HISTORIC LANDMARK COMMISSION
APPLICATION FOR A CERTIFICATE OF APPROPRIATENESS
JUNE 28, 2021
C14H-2010-0009; HR-2021-041008
VOSS HOUSE
1501 NORTHWOOD ROAD

PROPOSAL

Construct a rear and second-level addition.

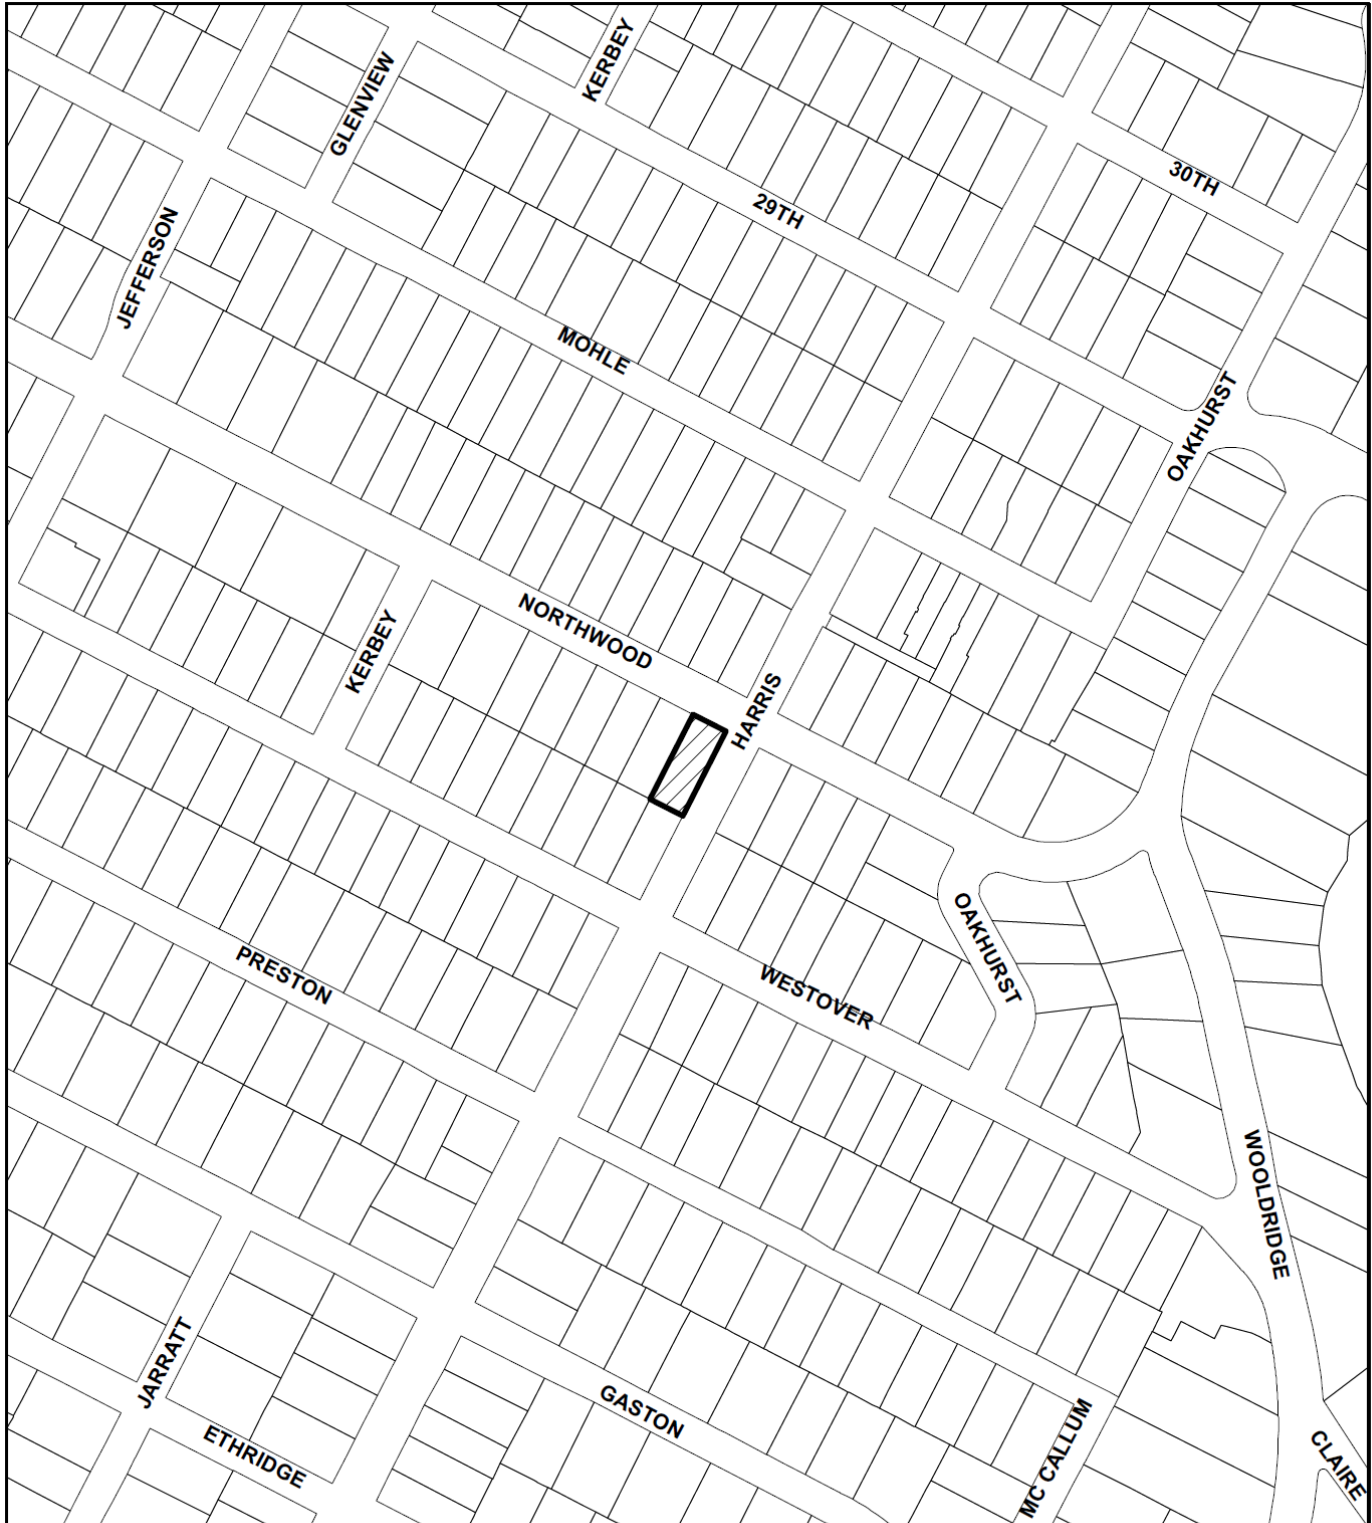
At their April 26, 2021 meeting, the Commission postponed the public hearing and referred the case to the Architectural Review Committee (ARC). At the May ARC meeting, Committee members expressed concern regarding multiple aspects of the project and the extent to which the design would modify a historic landmark on a corner lot. The second-story addition was described as encroaching on the one-story feeling of the landmark, and the long span of the side dormer as drawing attention to itself. Committee members recommended lowering the height of the addition and/or pushing it towards the rear of the house as much as possible. Alternately, members suggested a two-story addition with a hyphen at the rear of the property. The applicant explained that the rear addition has been designed around a large pecan tree in the back yard. Committee members also recommended retention of the grouping of four double-hung windows on the rear elevation, rather than installation of a large metal window. The applicant argued that the rear elevation appears to be a porch enclosure, rather than original to the house, and is not highly visible from the side street.

At the June ARC, the applicant presented an updated design that addresses prior feedback. Committee members indicated that the new proposal better respects the form and design of the historic house. Changes include significantly reducing the size of the second-story addition and retaining three of the four grouped windows on the rear elevation. The applicant asked to revisit the large window from the prior design; committee members indicated that the enclosed porch may be a historic-age alteration, and the house in its entirety was designated as a landmark. Committee members suggested retaining or salvaging the windows to be removed at the rear addition.

The design presented for Commission approval is unchanged from the June Committee meeting.
